**UPDATE 1 to the
TECHNICAL DRAINAGE STUDY
for
Fort Apache-Sky Pointe Storage**

UPDATE 1 to the TECHNICAL DRAINAGE STUDY for Fort Apache-Sky Pointe Storage

Re: Response to NDOT Comments for Fort Apache-Sky Pointe Storage
Reynolds Engineering Co. Job No. 21011

TECHNICAL DRAINAGE STUDY
Fort Apache-Sky Pointe Storage
95 Storage LLC
Clark County

APPROVED GRADING PLAN FROM ADDENDUM 2 TO TDS

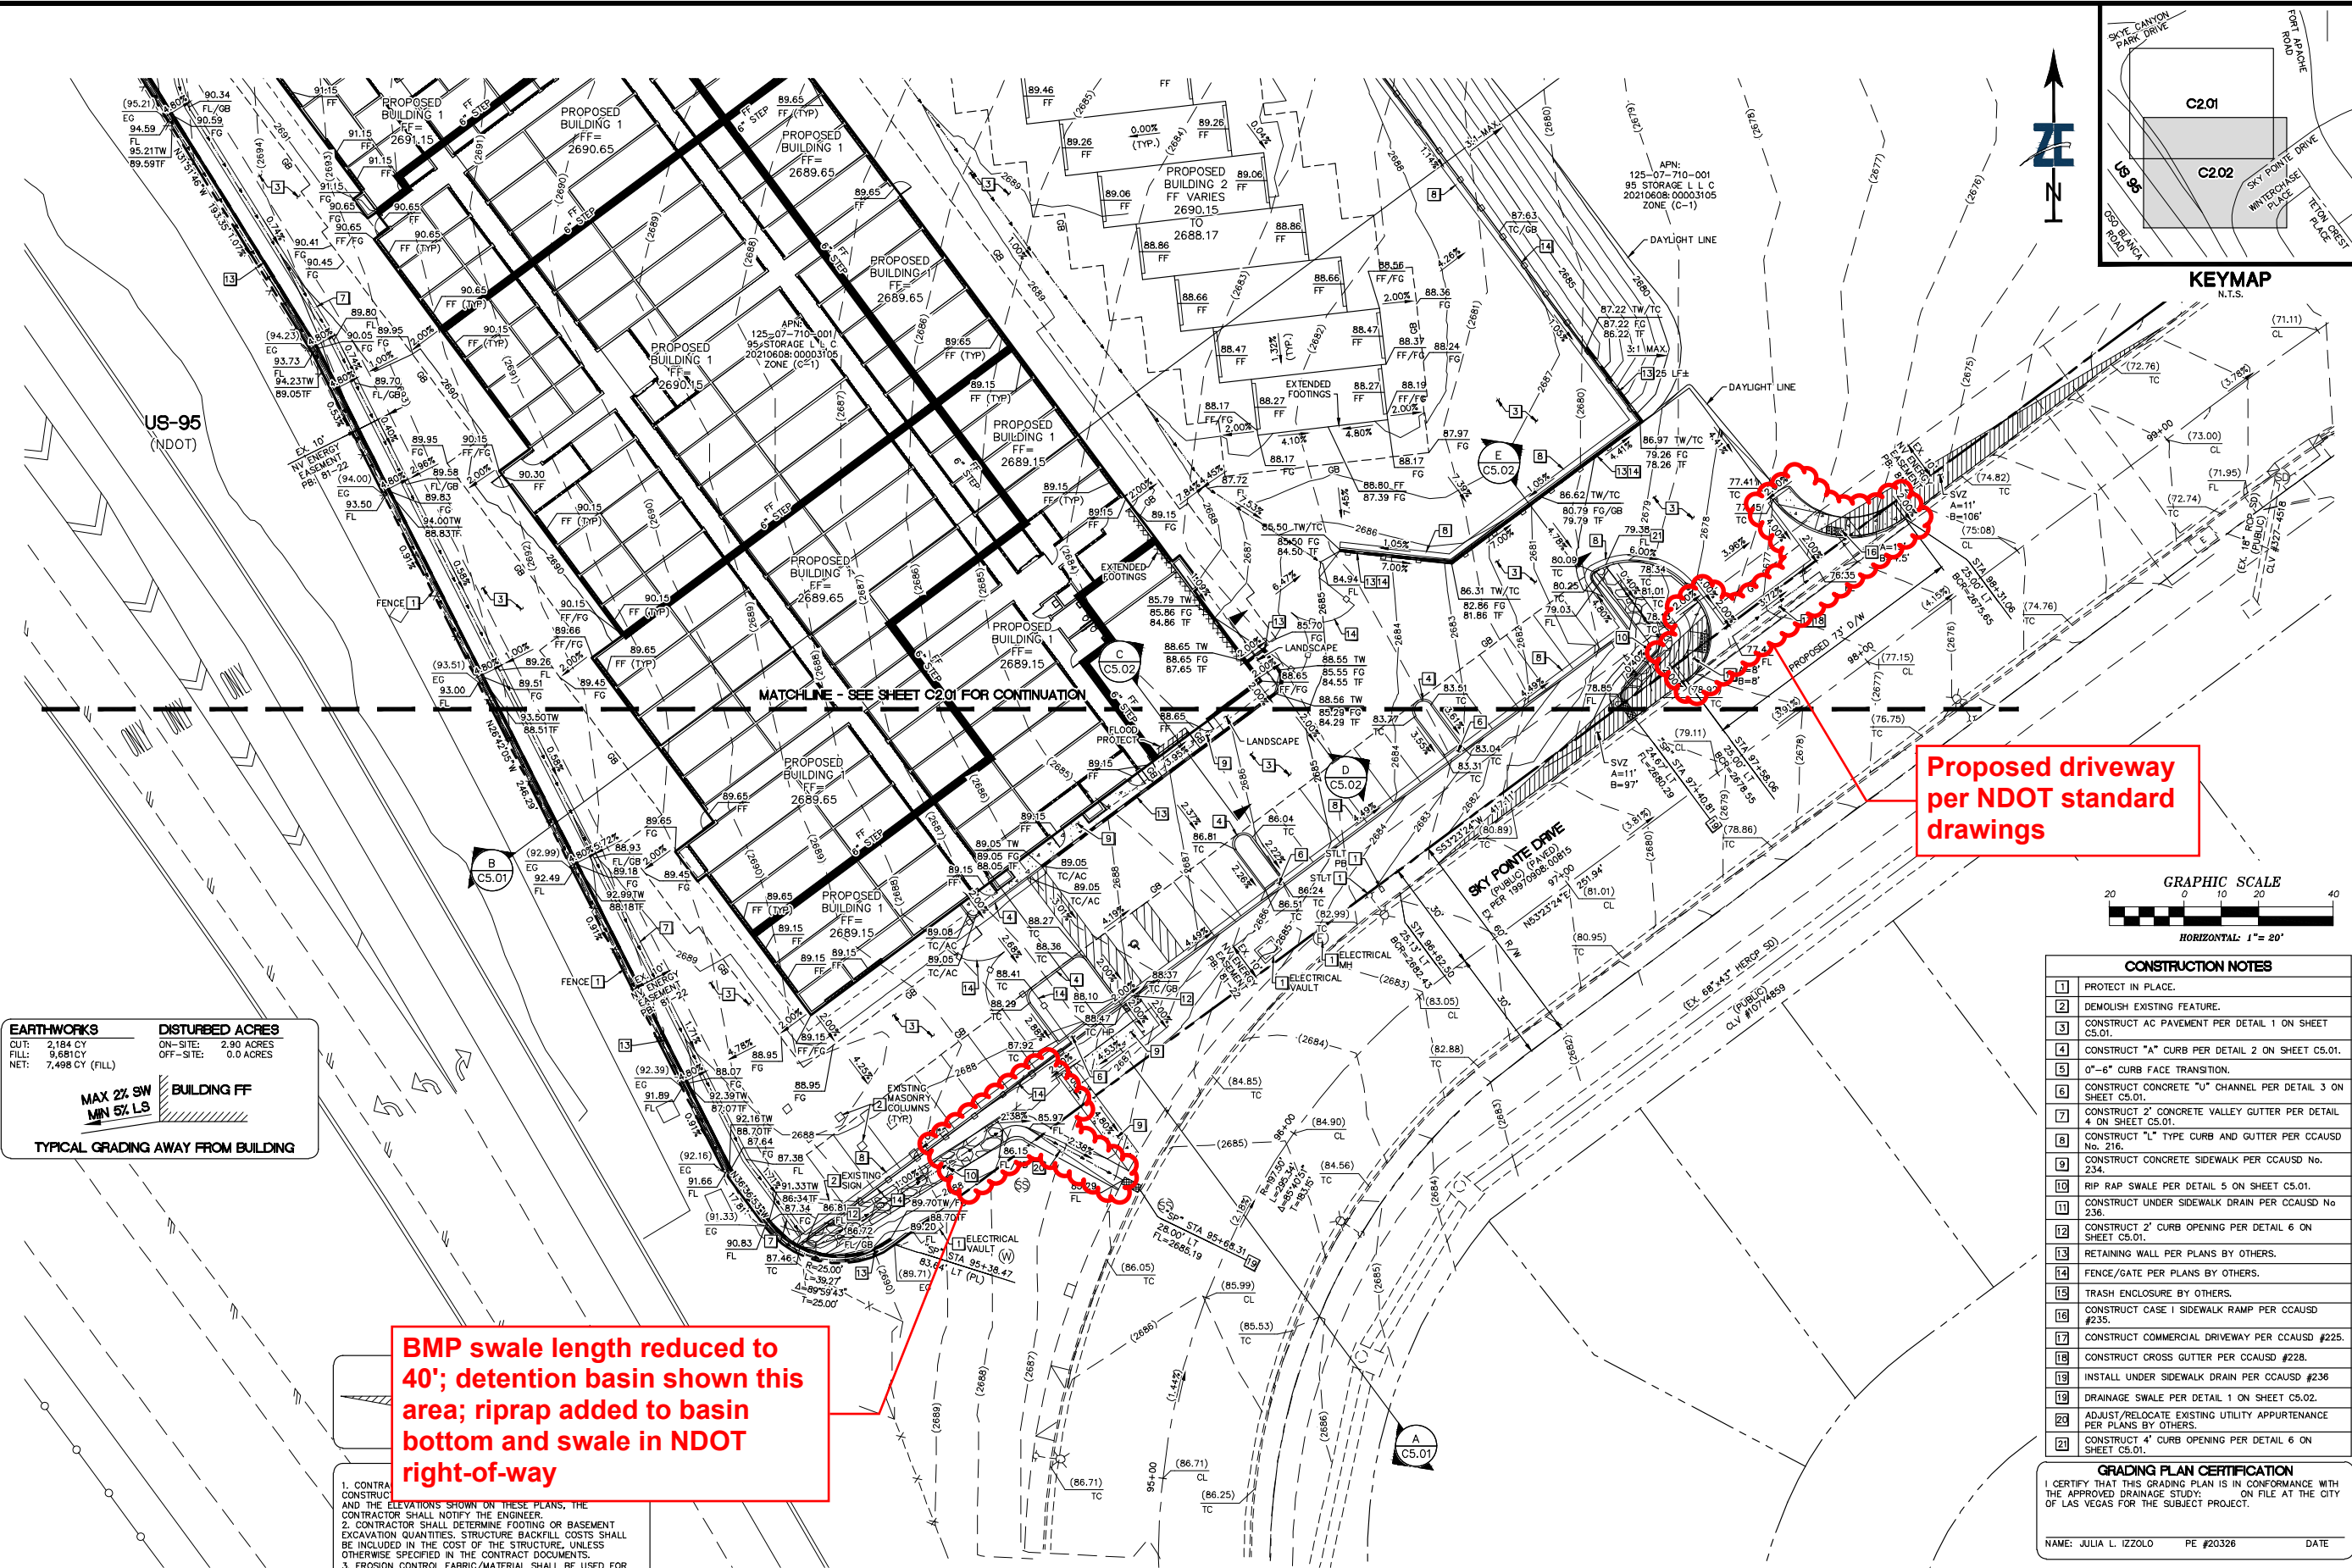
BMP swale length reduced to 40'; detention basin shown this area; riprap added to basin bottom and swale in NDOT right-of-way

Cross Section for Section 1 - N 1/2 Sky Pointe Dr (Int 10-yr)

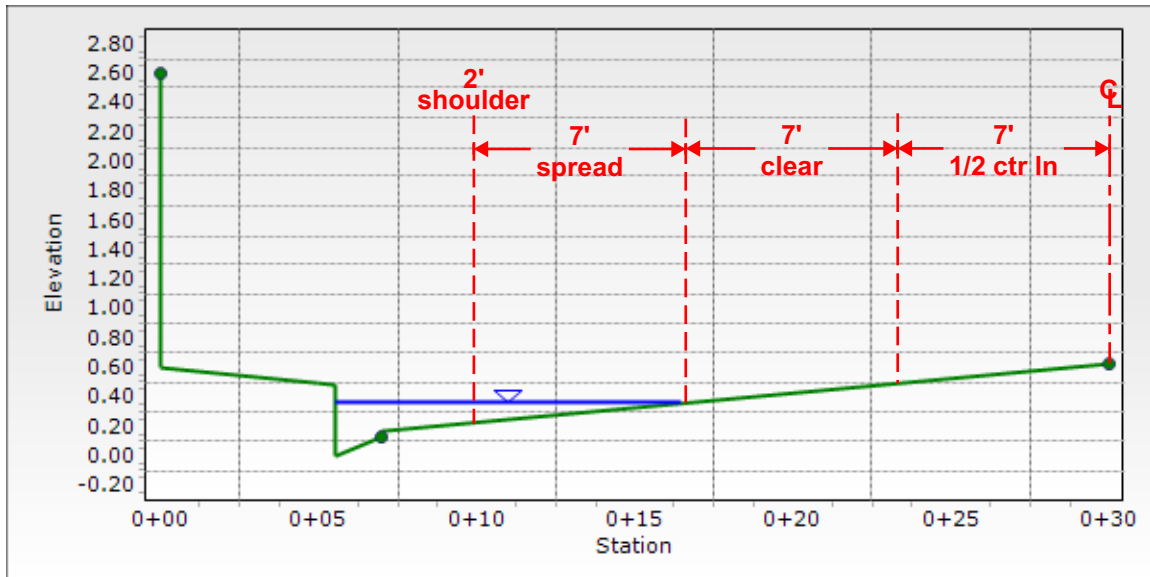
Comment 1: Please include additional drop inlets to contain spread violation on Sky Point Dr, and submit spread calculations.

Response 1: It is unreasonable to request this project install new storm drain and drop inlet in Sky Pointe Dr to remove 1 cfs from the roadway to meet the spread criterion. Instead, a detention basin behind solid grout CMU wall with a 12" x 8" opening has been added in the southwest of the site to detain a portion of runoff from on-site basin OND1. The design limits 10-year flow from OND1 into Sky Pointe Dr to 1 cfs. Peak 10-year flow in the roadway has therefore been reduced to 6 cfs. Spread in the 14-ft wide travel lane has been reduced to 7 ft, or 1/2 lane width as required.
